# Access Compliance Report

## Public Rights-of-Way

Intersection ID: 49250	Main Street: RIDGE_PATH_LN	Cross Street: BOOMERANG_WY	Location: W
ADA ID: 78F38CBDF0E6	Ramp Type: BlendTrans1	Initial Pass/Fail: Fail	Overall Compliance: No
Severity Score: 8.75			
Codes/Mitigation Info/Possible Solution		Field Measurements/Component Compliance

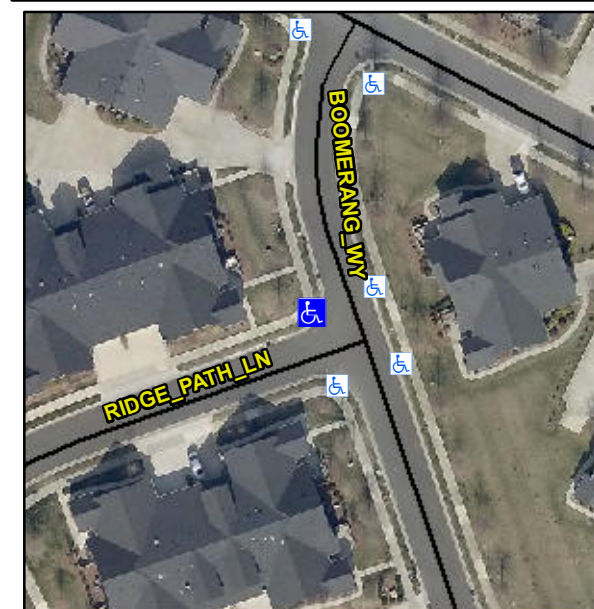
**LNDG LIP 0.5**

**Not Found, R304.5.1**

**Remove & Replace Curb Ramp With Two New Directional Ramps or Equivalent.**
